# CUSTOMER ADVISORY

## ADV2002

### Label Content Update for FPGA and Power Products

**Table 2: Label Sample with “RoHS COMPLIANT”**

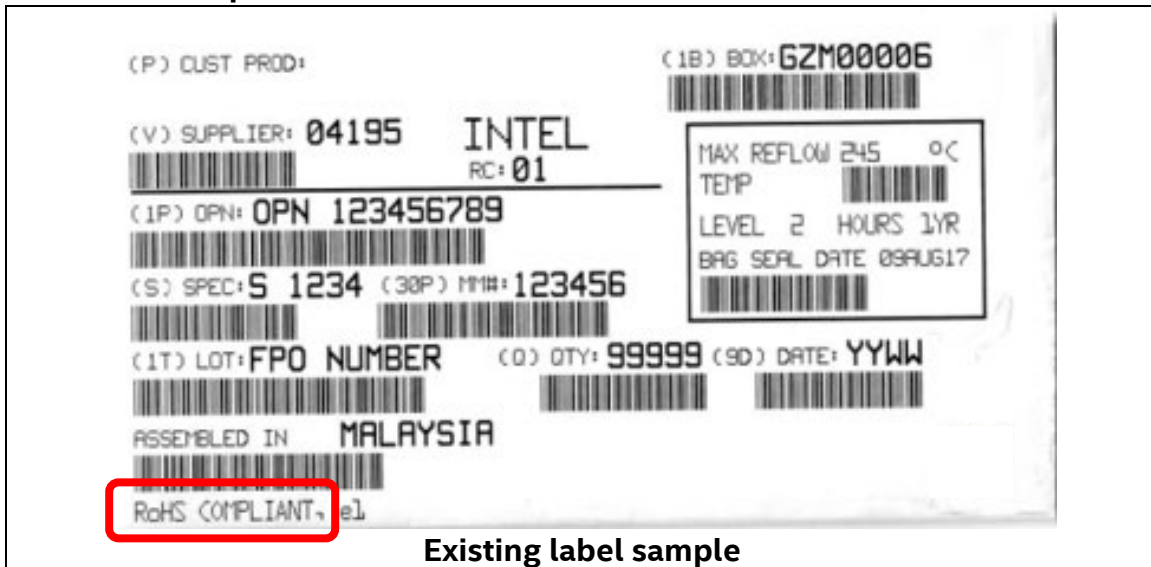
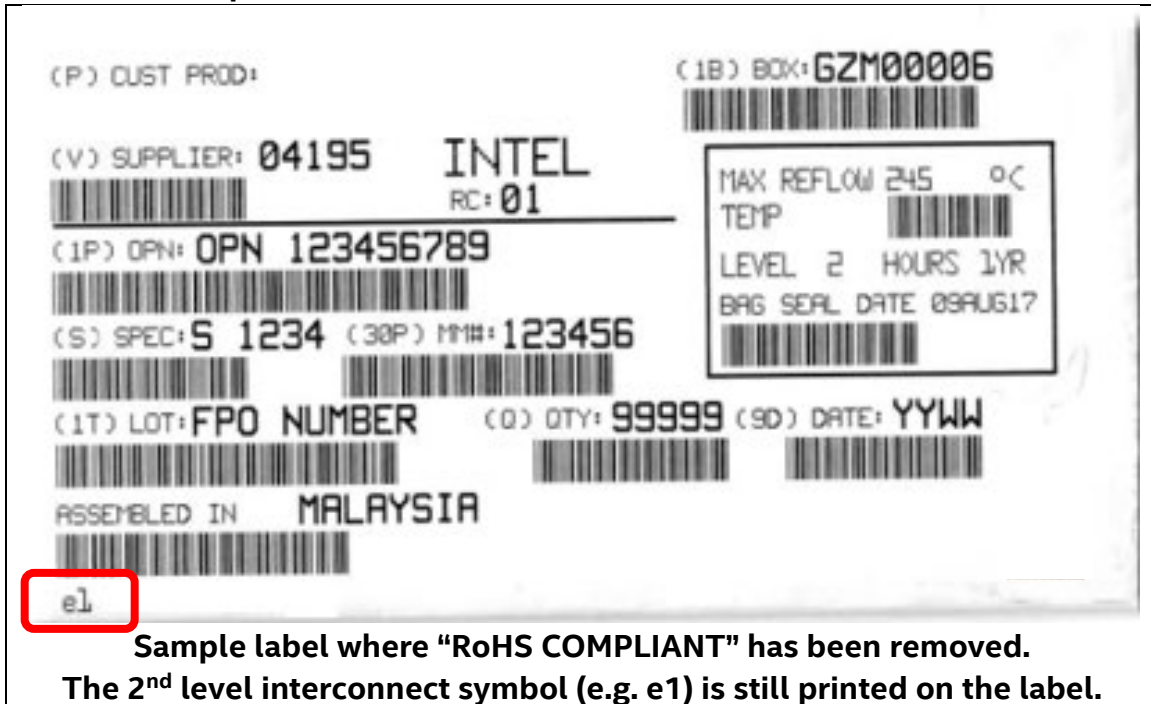
Change From	Change To
"RoHS COMPLIANT" indicated on the lower left of the barcode label	Labels may or may not indicate " <b>RoHS COMPLIANT</b> " on the barcode label.  The 2nd level interconnect symbol (e.g. e1) remains printed on the label.
